Subject: Annual Inspection Report
Eufaula (Weedon Field) Municipal Airport

ANNUAL INSPECTION REPORT

EUFAULA (WEEDDON FIELD) MUNICIPAL AIRPORT
(KEUF)
EUFAULA, ALABAMA

Photo # 1 – Runway 18 Approach

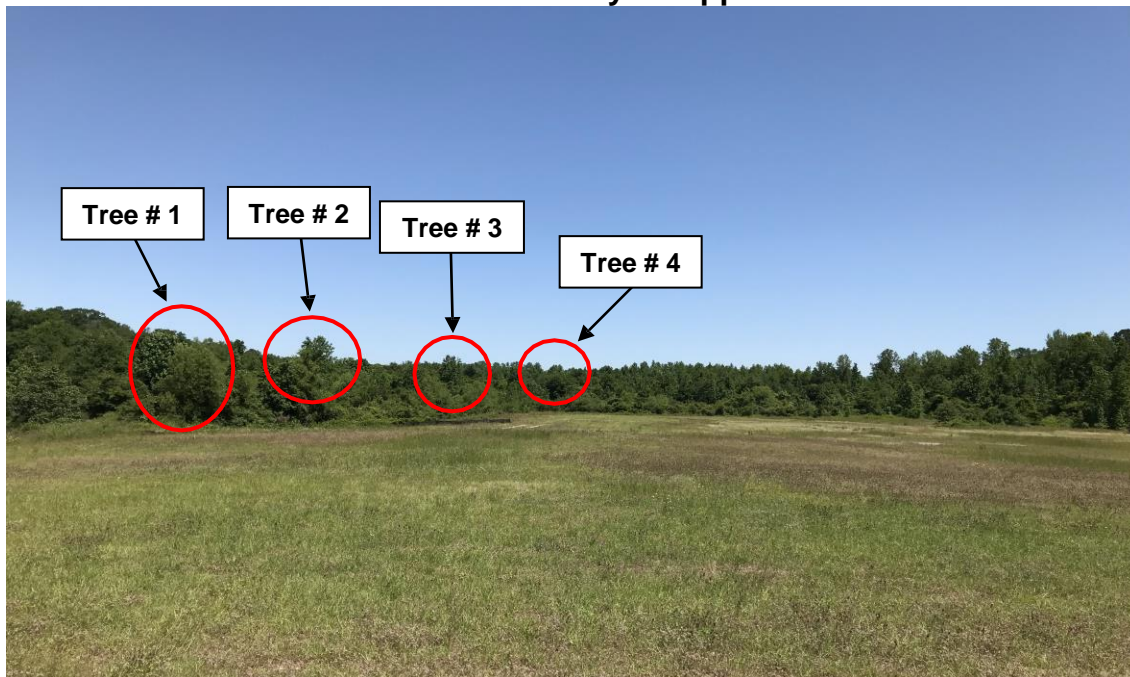
- Runway 18 – Trees labeled #1, #2, #3, and #4 obstruct the required 20:1 approach slope (See Photo #1).
- Runway 36 – No obstructions (See Photo #2).

Inspection Area	Violation/Maintenance	Corrective Action
Approach/Departure Paths	VIOLATION	Remove all trees that obstruct the required 20:1 Approach/Departure Path on RWY 18
Airport Lighting	Maintenance	Repair/replace inoperative lights
Fueling Area	Maintenance	Re-inspect and tag fire extinguishers on Jet-A refueler

Eufaula Weedon Field (KEUF) *RWY 18 20:1 App/Dep Path* *May 7, 2020*

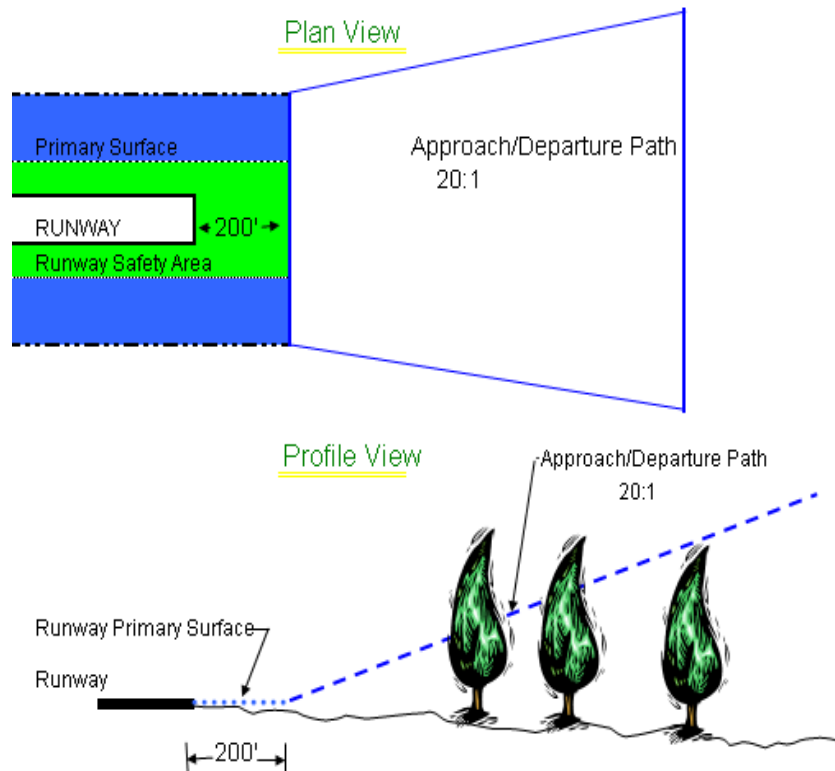
1. Tree 22' Abv. RWY End
 284' From RWY End
 130' Right of Cntln.
 11:1 Obst. Clnc.

2. Tree 19' Abv. RWY End
 311' From RWY End
 91' Right of Cntln.
 5:1 Obst. Clnc.

3. Tree 36' Abv. RWY End
 526' From RWY End
 150' Right of Cntln.
 2:1 Obst. Clnc.

4. Tree 32' Abv. RWY End
 755' From RWY End
 105' Right of Cntln.
 17:1 Obst. Clnc.
